DATE: August 6, 2020**FILE:** 3060-20/DP 3A 20
3060-20/DP 4A 20**TO:** Chair and Directors
Electoral Areas Services Committee**FROM:** Russell Dyson
Chief Administrative OfficerSupported by Russell Dyson
Chief Administrative Officer*R. Dyson***RE:** **Development Permit (Shoreline Protection) – Coal Hills, Island Highway (West Fraser Mills Ltd. and Province of British Columbia); That part of Lot 1 District Lot 154, Nanaimo District, Sections 31 and 32, Township 1 and District Lot 28, Nelson District, Plan EPP15507 as shown on Plan EPP56910, PID 030-110-254; Block B, District Lot 155, Nanaimo District, No PID****Purpose**

To consider Development Permits (DPs) under the Shoreline Protection Devices Guidelines related to the proposed land alterations to the shoreline at the Union Bay Coal Hills site (Appendices A, B and C).

Figure 4: Example Cross-sections illustrating Rip Rap design (A) and Softshore design (C)

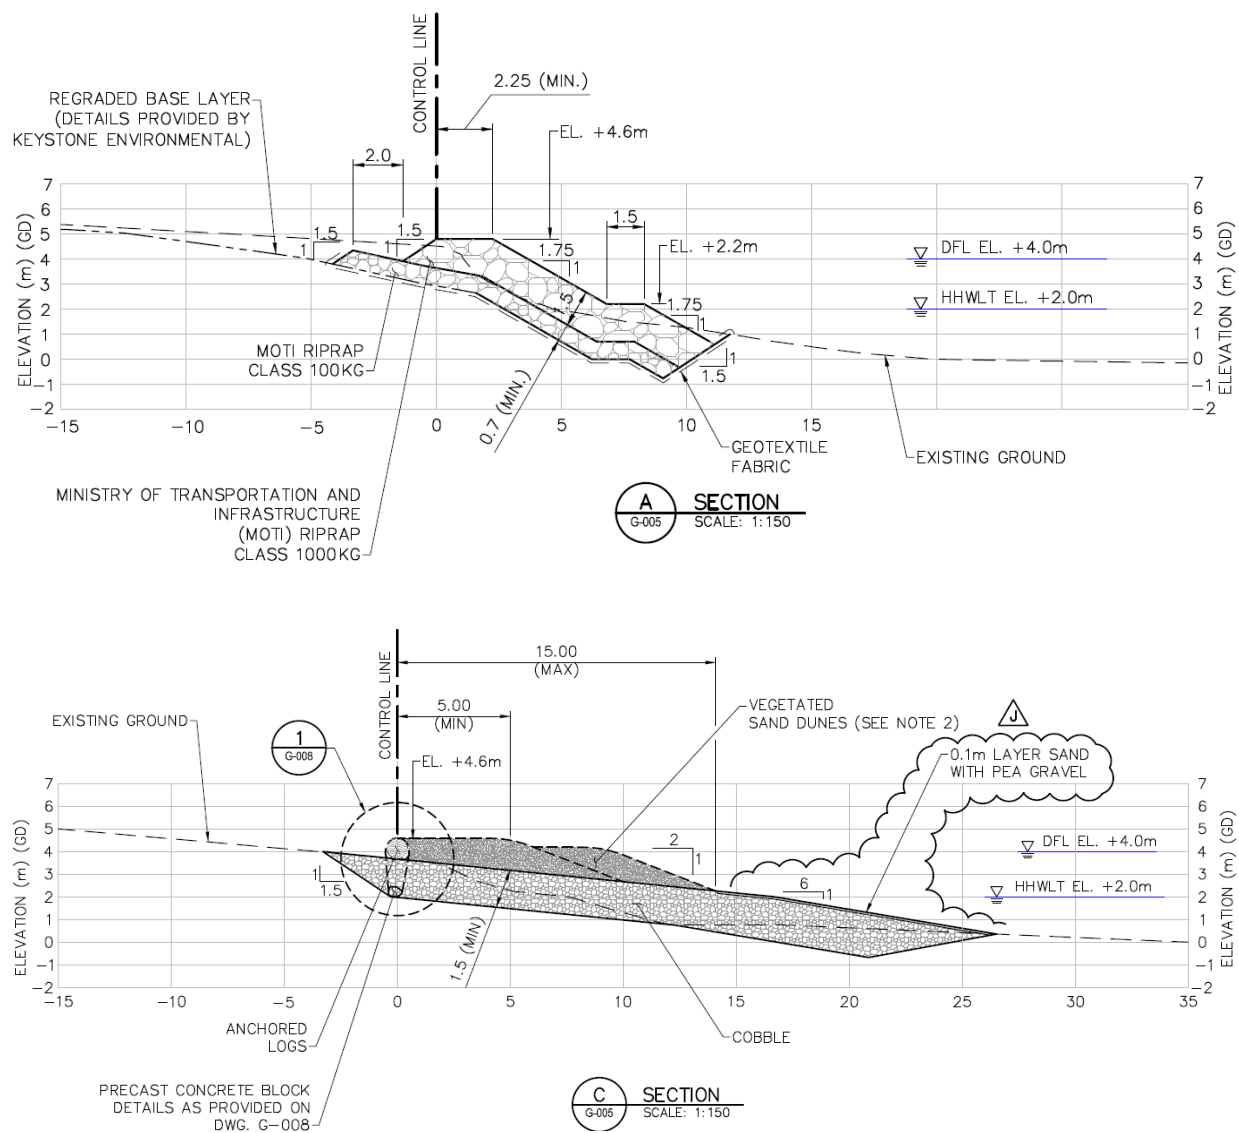
The rip rap structure (Figure 4) would consist of large boulders (~1.5 metre sized) laying ovetop of smaller boulders (at least 0.7 metres) underground, itself laying on top of a geotextile fabric. This design allows the rip rap structure to be keyed into the beach to inhibit movement and scour. It would reach a maximum height of 4.8 metres above sea level (measured from the geodetic datum), in accordance with the calculated designated flood level (accounting for sea level rise to 2100 and a 1-in-200 year storm surge), at an approximately 1.75H:1V to 3H:1V slope. To ensure long term stability under static and seismic conditions, a report was submitted titled *Riprap Stability Assessment* prepared by Kevin Bodnar, P.Eng. of Geopacific Consulting Engineers.

The softshore measures being taken on the northern side would follow a Green Shores-style approach. It would re-grade a foreshore area to a more gradual slope with cobble underlying a thin layer of sand and pea gravel. Vegetated sand dunes would be placed between the higher high water large tide level and the designated flood level, on top of the cobble and against anchored logs (Figure 4). According to the qualified professionals, this design would both prevent pollutants from entering the aquatic environment and be suitable for forage fish spawning.
